Our ref: P680020-FRA L02
Your ref: 21/02286/F

Re: Construction of a coffee unit with drive-thru facility and indoor seating with associated access, car parking, landscaping and servicing parking. Land North West of Launton Road roundabout adjoining Skimmingdish Lane, Caversfield

I refer to the recent Environment Agency consultation response (EA Ref: WA/2021/129266/02-L01 dated 9th December 2021) to the above application. This response maintains the objection to the application on the grounds that the latest proposals for the flood compensation provided by the scheme is not in line with the previous consultation and agreements with the Environment Agency.

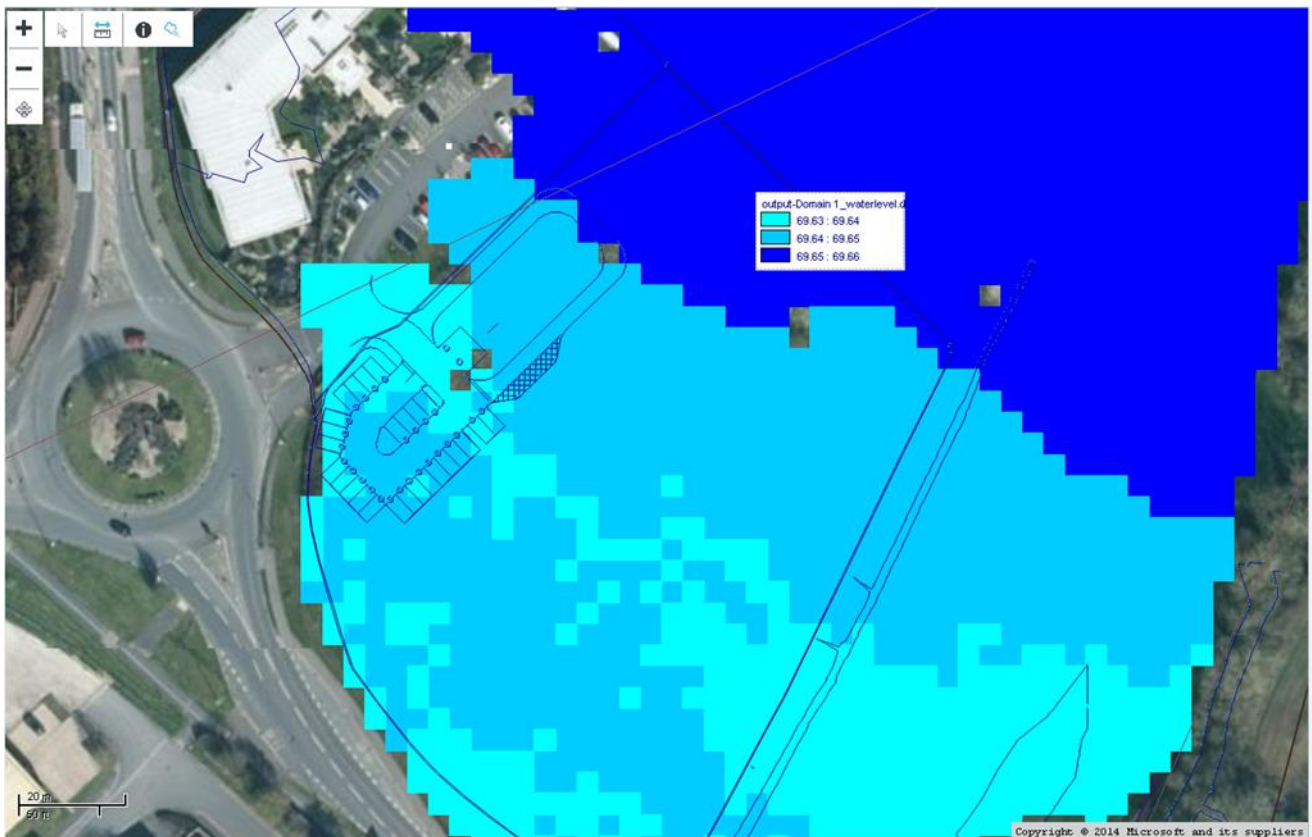
In July 2021 the revised allowances were published and should be used for all planning applications. According to the guidance published by the Environment Agency, the appropriate and central allowance to assess off-site impacts and calculate floodplain storage compensation depends on land uses in affected areas. Given the lifetime of the development is expected to be less than 25 years (the Tenant has committed to a 15 year lease), the 2050 allowance has been used. For the Cherwell and Ray catchment, the central allowance for the 2050 epoch is a 4% increase in river flows (See extract below).
